Attention: May Li, Assessing officer,  
Lane Cove Council  
PO Box 20 Lane Cove  
NSW 1595

Your ref: DA # 233/2011

**RE: revised comments following a meeting with the applicant receipt of amended plans  
SEPP 65 COMMENTS AND RECOMMENDATIONS**

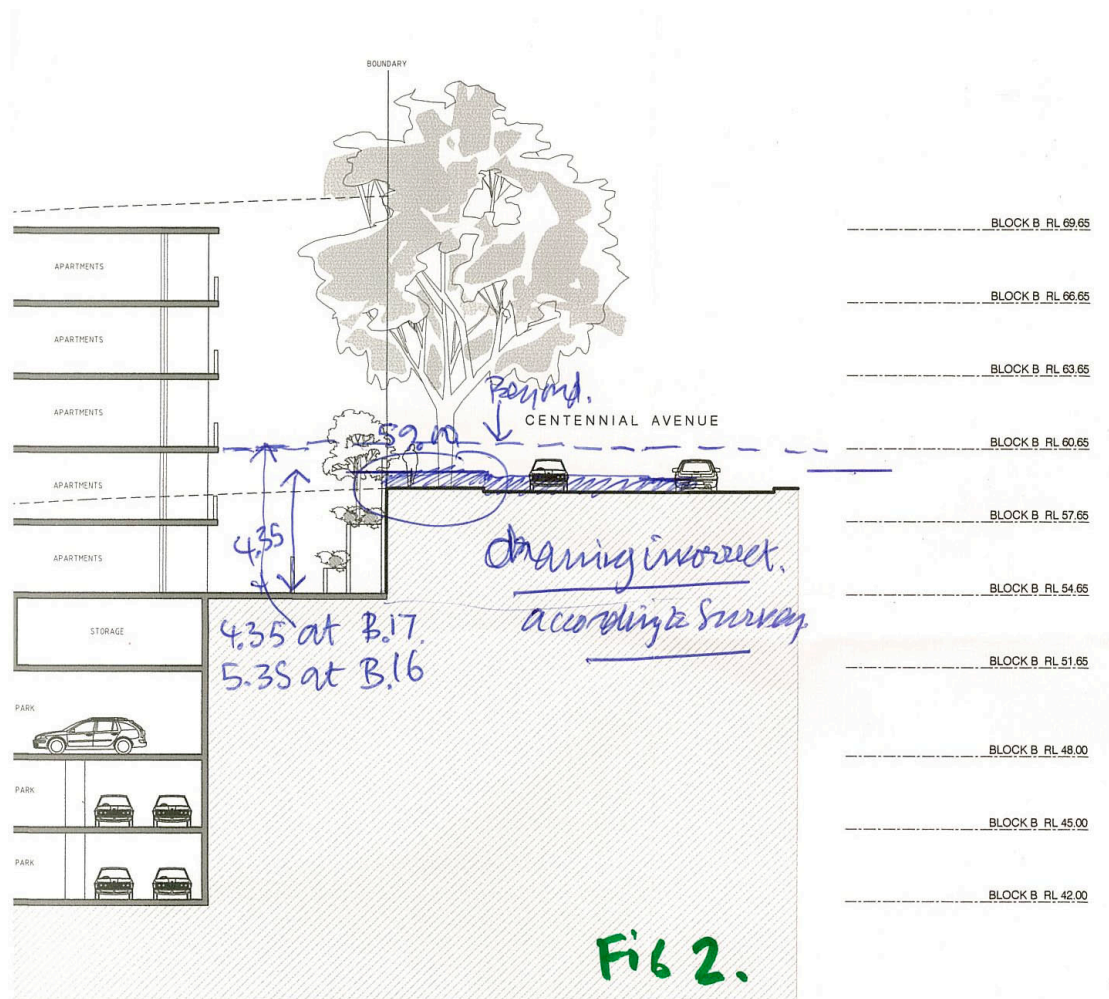
Similarly, figure 2 (which is the applicants section CC, which incidentally was drawn incorrectly according to the survey) shows the relationship between building B and Centennial Avenue. Lower-level units along this boundary vary from 4.35 m below natural ground level at B 17 to 5.35 m (close to 2 storeys) below ground level at B 16.

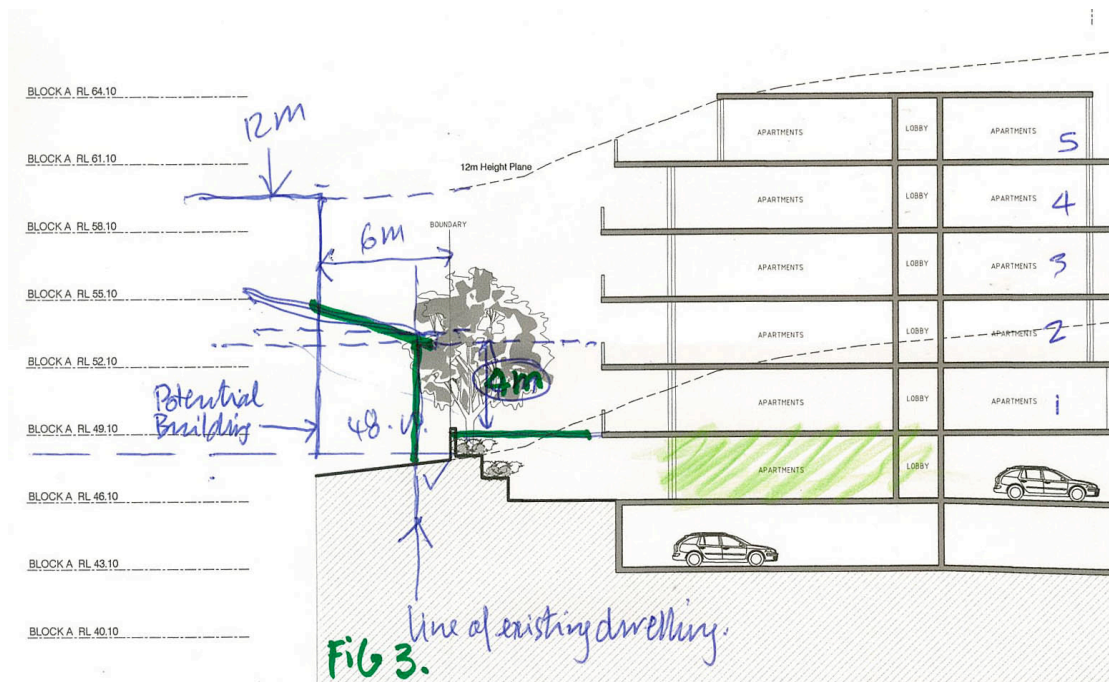
Figure 3 (also section CC) shows the relationship between block A and the property to the north west of the site. This section is taken through the most advantageous part of the site. If a section had been taken adjacent to unit A21, the difference between the natural ground level, 53 to 54 m and the proposed level of the unit, the difference would be 4 to 5 m, again, an unacceptable depth to be living below ground.

Beyond.  
 height difference is more than 4m  
 between Boundary 53-54m and  
 Ground level. 49.1 . Unit A.21.

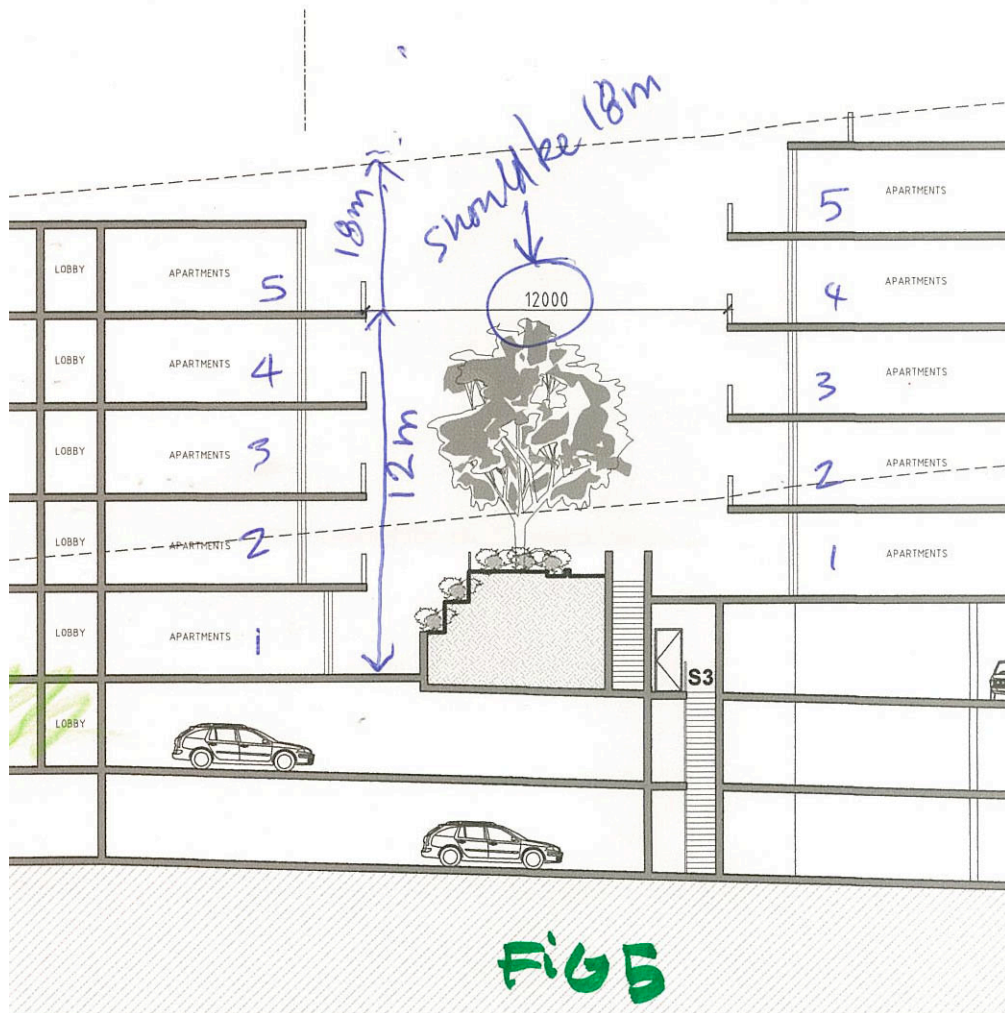
The applicant has calculated the solar access numbers based on an assumed stepped building being on the property north of the site. This diagram can be seen on page 22 of their letter addressed to Council dated 23rd of March 2012. It cannot be assumed that the development to the North will follow this form. It can only be assumed that this property will be subject to the same controls as the subject site. This equates to a setback from the boundary of 6 m (minus some permissible encroachments) to a height of 12 m.

This probable building form will have serious consequences with respect to the solar access to building B, further exacerbating its already poor amenity especially at the lower levels. Similarly, potential development on the property to the North West of block A will affect the amenity of that building.
